QUALITY ASSURANCE -- NON-CONFORMANCE REPORT

Report No: NCR-000934

Reference Description: ZPMC removed welds and re-welded without Engineer's approval and QC presence over 30 minutes (Steel Barriers E5-SB13-066 and E5-SB13-072)

To:	AMERICAN BRIDGE/FLUOR, A JV 375 BURMA ROAD OAKLAND CA 95607	Date:	10-Dec-2010
Dear:	Mr. Charles Kanapicki	Contract No:	04-0120F4 04-SF-80-13.2 / 13.9
Attention:	Mr. Thomas Nilsson Project/Fabrication Manager	Job Name:	SAS Superstructure
Subject:	NCR No. ZPMC-0895	Document No:	05.03.06-000891

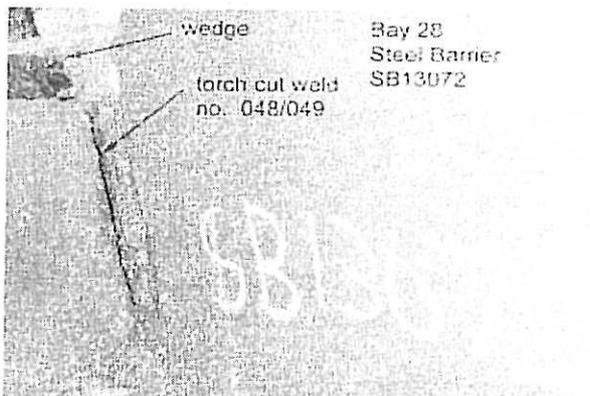
-The Contractor did not notify the Engineer of the intent to remove welds E5-SB13-066-048, 049, 050, 079, 080, 081, 084, and 085; E5-SB13-072-048, and 049 as identified in the pictures.

-Subsequently, ZPMC workers performed welding at several above mentioned locations, such as E5-SB13-066-050 as seen in the picture below.
